CUSTOMER ADVISORY

ADV1917

Intel® Enpirion® Power Solutions Package Outline Drawing Update

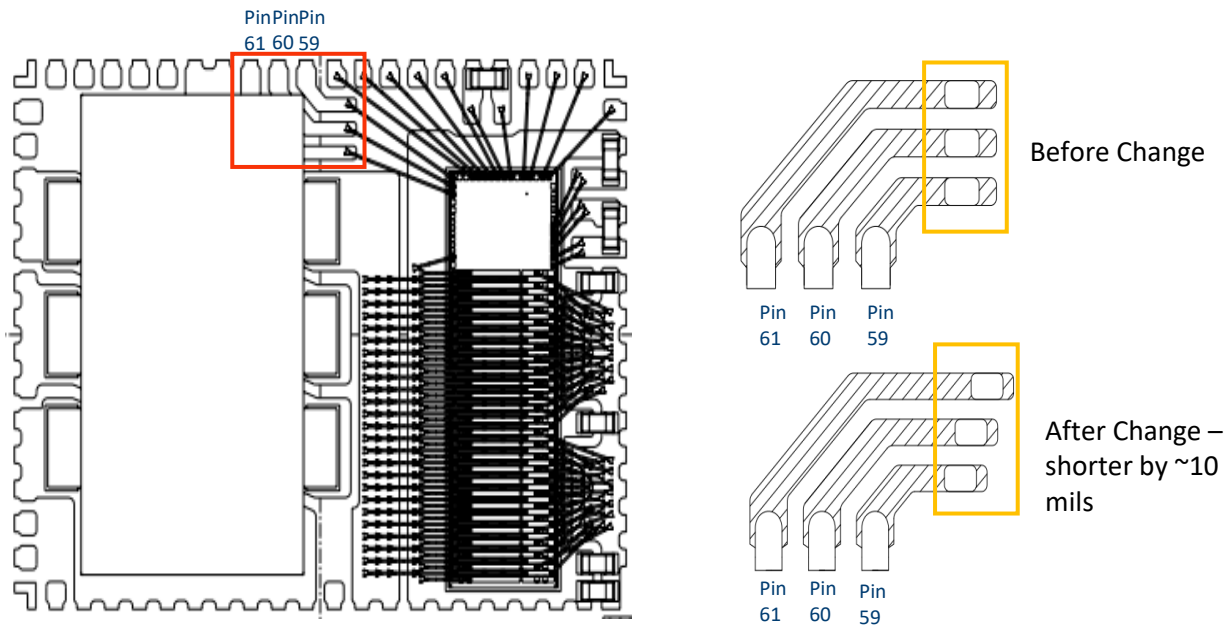
This is to reflect the current exposed pads design in the POD. The following is the visual representation of the change.

Alignment of the package outline drawing to the actual exposed pads design of the lead frame.

No additional action required as there is no impact to the fit and function of the product and the affected pads are not electrically connected or soldered in the customer's board assembly process.
